COMMUNITY DEVELOPMENT DEPARTMENT REPORT

SUBJECT: Pine 43 Mixed Use Subdivision – ALT,
AZ, CUP, MDA, PP, RZ
H-2024-0071

**E. Proposed Conceptual Master Plan to be Included in Amended Development Agreement –
NOT APPROVED**

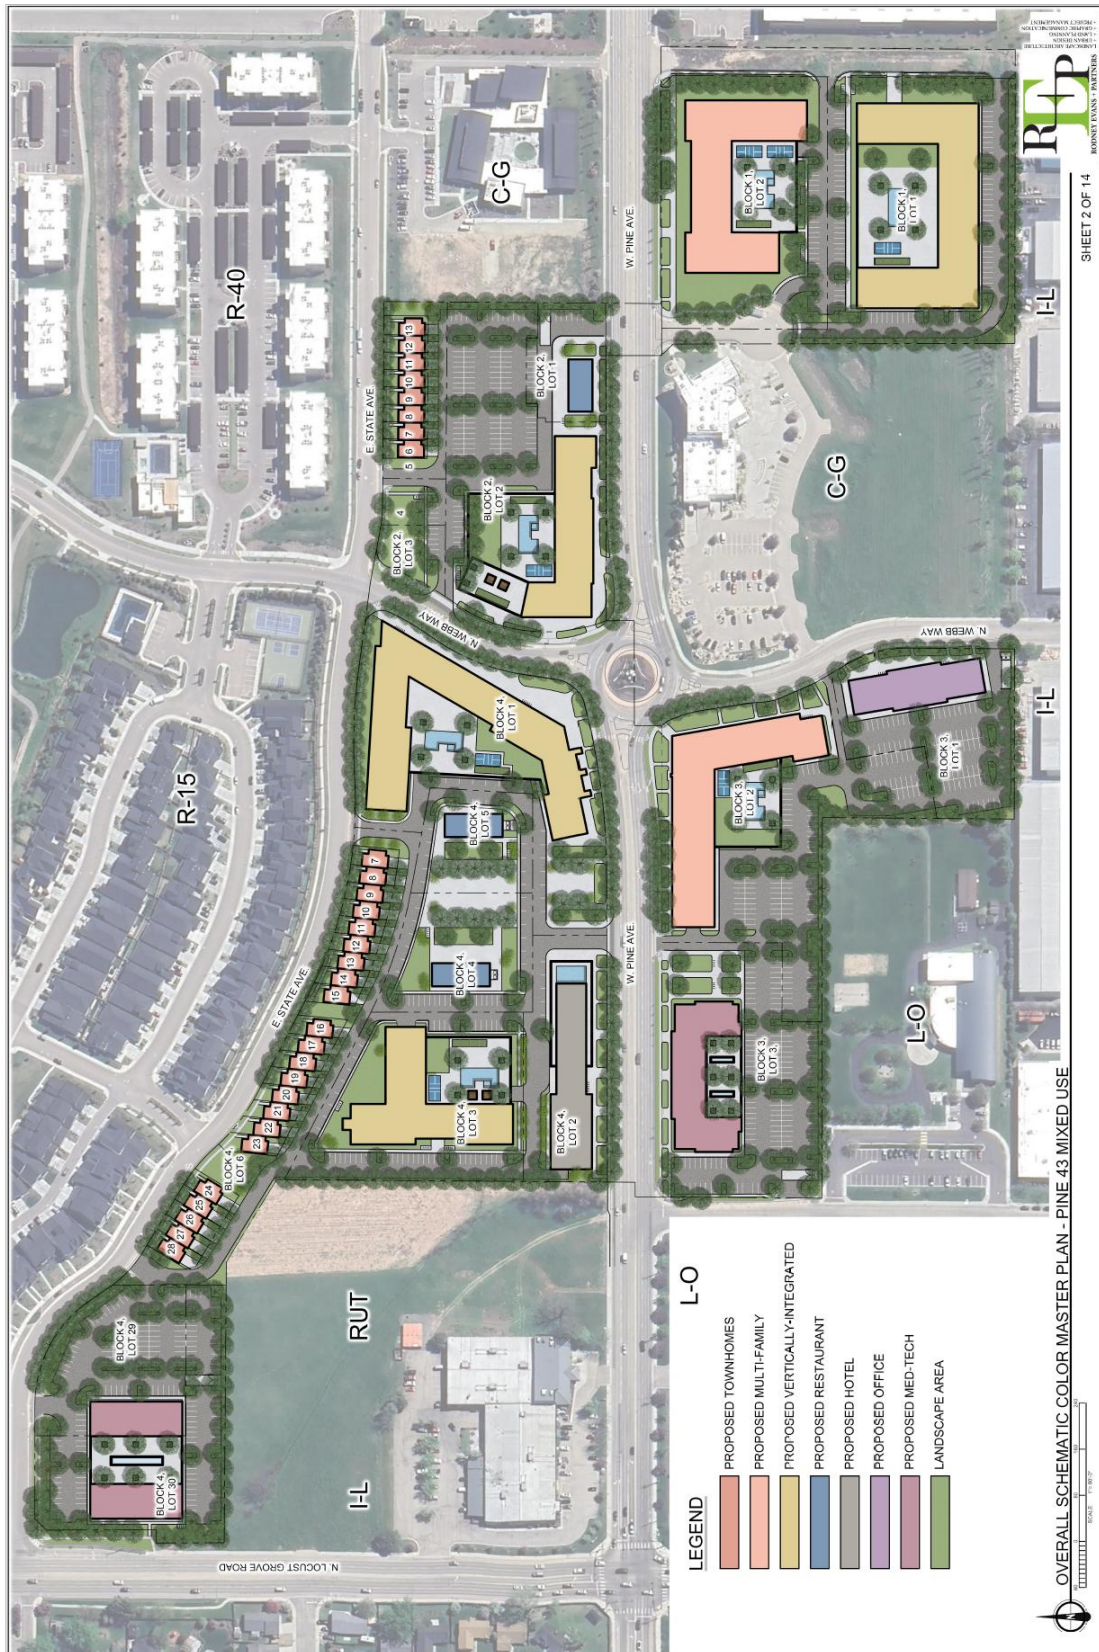
Staff is generally supportive of the portion of the proposed concept plan north of Pine as it provides a mix of uses as desired for MU-C designated areas. However, Staff is concerned the proposed amendment would substantially reduce the amount of land designated for employment-generating uses, which may in turn limit future opportunities for family-wage jobs within the area. A total of 713 residential dwelling units were entitled and have been constructed in the northern portion of Pine 43 north of E. State Ave. An additional 466 (maximum) vertically integrated residential units are proposed in the development area between State Ave. and Pine Ave. with an additional 409 vertically integrated residential and multi-family apartment units proposed south of Pine with the amended master plan.

For these reasons, it's Staff's opinion the previously entitled development plan for commercial uses in the area south of Pine where multi-family and vertically integrated residential uses are proposed is in the best interest of the City to retain as it provides needed employment opportunities and services for nearby residents, while also reducing vehicle trips and supporting trip capture.

Additionally, it's Staff's opinion the vertically integrated residential use on Lot 1, Block 1 is not compatible with adjacent industrial uses and operations to the south. Industrial operations typically produce impacts such as noise, vibration, light pollution, and emissions, which can negatively affect the health, safety, and overall livability of nearby residential environments. Therefore, Staff recommends the concept master plan is revised to reflect commercial/office uses in the area south of Pine Ave.

N. Overall Open Space Exhibit – NOT APPROVED

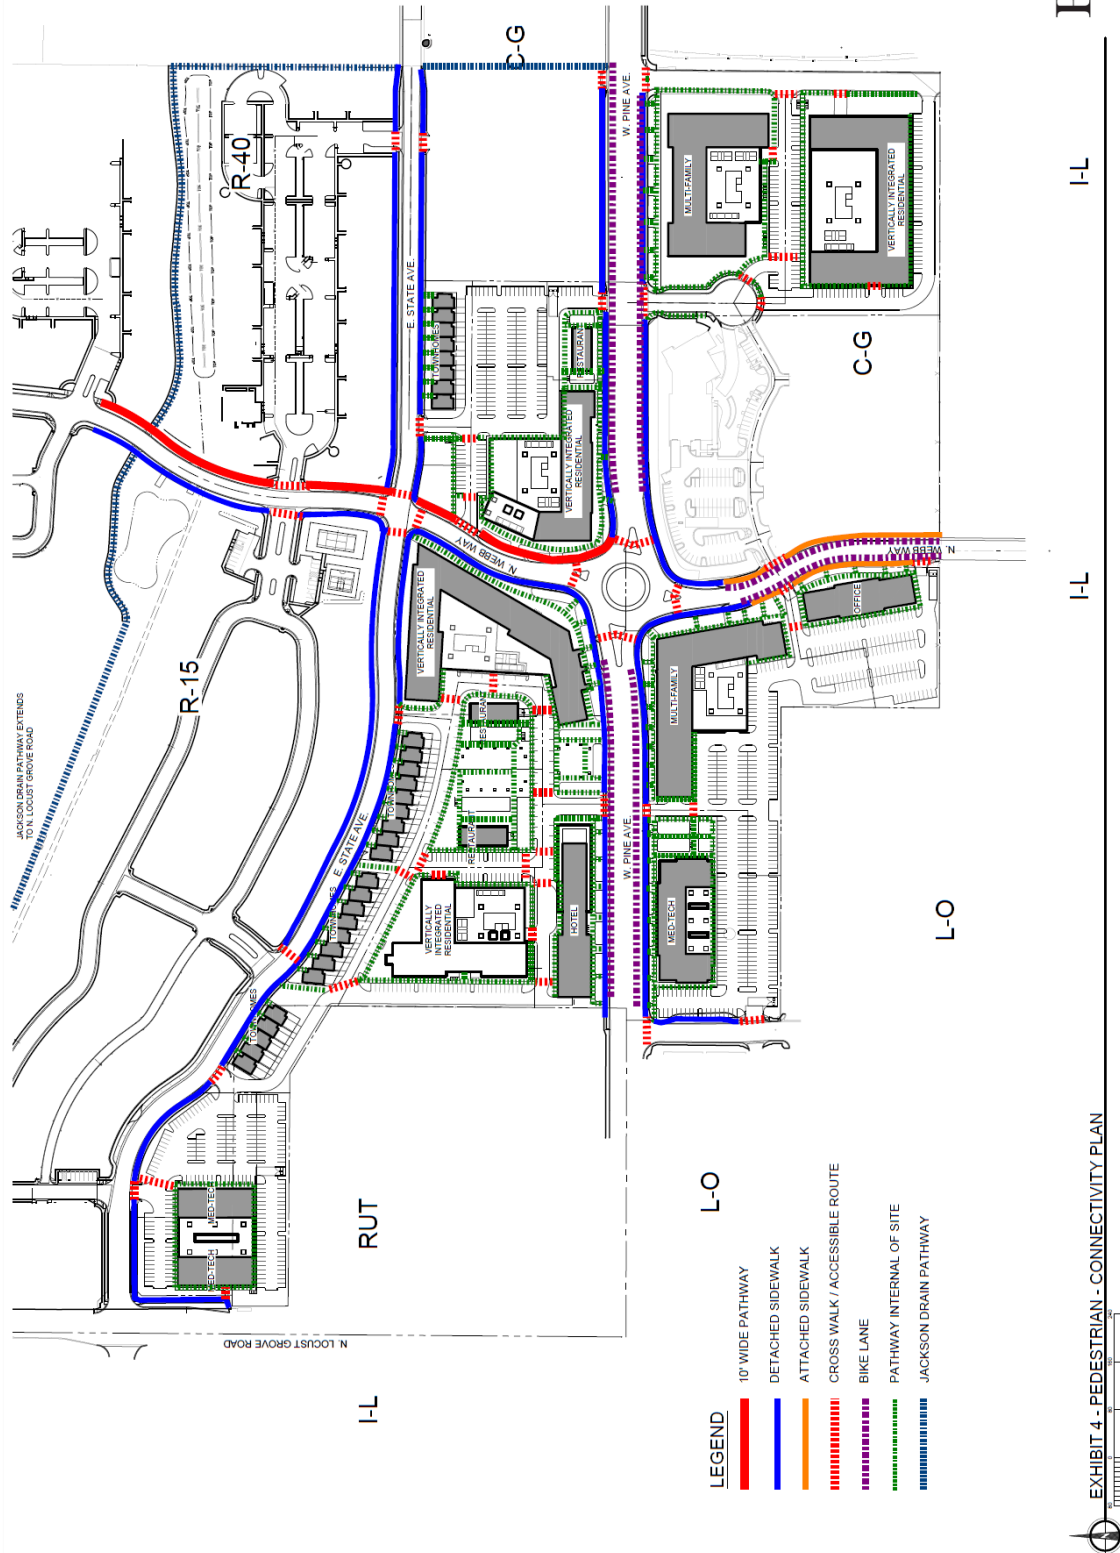
The exhibit in Section VII.N depicts open space on non-residential lots but appears to include portions of the street buffers along Pine Ave. on Lot 3, Block 3 and Lot 2, Block 4, and Lot 1, Block 2, which should not be included. Staff recommends a revised open space exhibit is submitted prior to the City Council hearing that excludes street buffers with details of the public/quasi-public spaces and places with amenities, landscaping, pathways, etc. No schools are proposed within the site; however, there is an existing school southwest of Block 3.

*Based on the subject area of subject south of State Ave. (36.58 acres), a minimum of 1.83 acres of such spaces and places should be provided; an open space exhibit is included in Section VII.N that depicts open space for non-residential lots. A 0.95 acre public plaza is proposed centrally within Block 4, which is the main feature; other areas are shown on the plan by the proposed hotel, med-tech building and east restaurant consisting of 0.85 acres for a total of 1.8 acres. **Some of these areas appear to be in the street buffer along Pine Ave. and do not qualify as noted above. A revised open space exhibit should be submitted that excludes these areas, that demonstrates compliance with the minimum area, and includes more details.***
